STATE OF VERMONT
AGENCY OF TRANSPORTATION

PROPOSED IMPROVEMENT
BRIDGE PROJECT

TOWN OF WARREN
COUNTY OF WASHINGTON
BROOK ROAD (T.H. 1, CLASS 2), BRIDGE NO. 7

RECORD PLANS

NORTH RAILING ELEVEATION – FACING NORTH FROM CENTERLINE OF ROADWAY
SOUTH ELEVATION SIMILAR

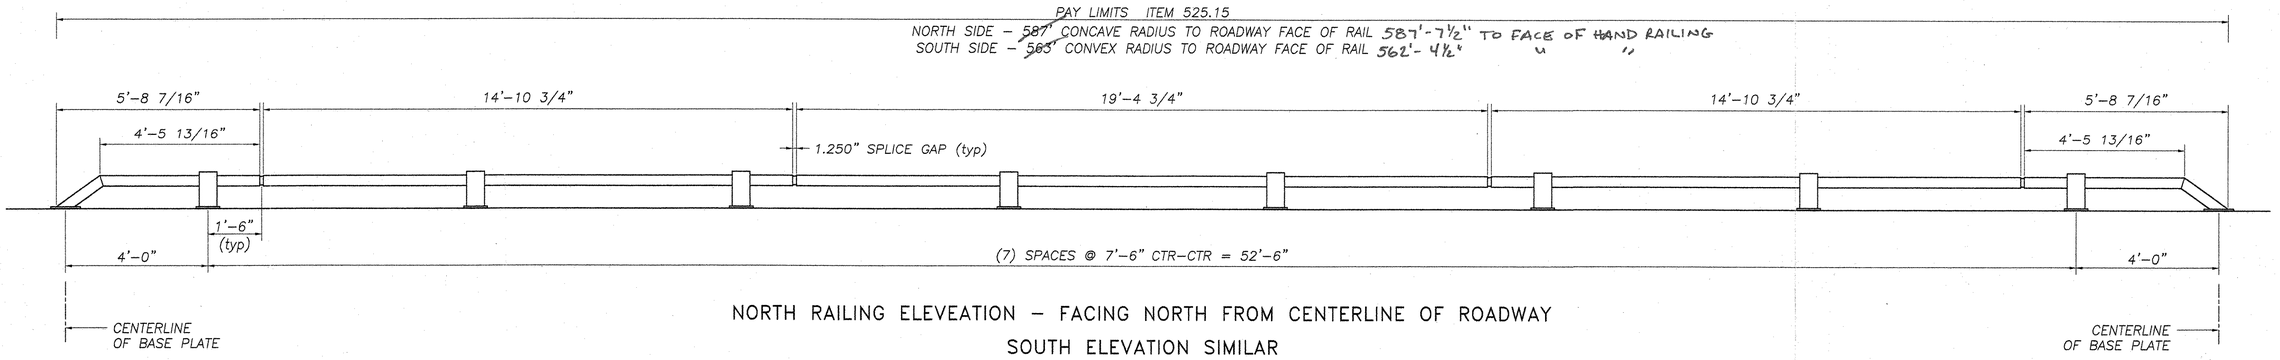
Sheet 2 of the Shop Drawings, under the Bill of Materials, notes "Stainless Steel Post Anchors provided by others". Since those anchors are a part of the pay item I assume they are to be provided by F. R. Layfayette. **A submittal of the data sheet for the anchor bolts that are to be used is required, and full approval of the Shop Drawings for this item will be contingent upon receipt and approval of an acceptable data sheet.**

Sheets 1 and 2, Welding Procedures W-1600-a, W-1600-b, and W-1600-c, Painting procedure for galvanized surfaces, and selected paint system data are approved or approved as noted. The data sheet for the T-Anchor is rejected. As per my conversation with Paul Radice of your company we have agreed to substitute a galvanized bolt installed in a tapped and threaded hole in the pipe in lieu of the toggle bolt as shown. A letter, dated Aug. 9, 2007, requesting that change has been received and is approved.
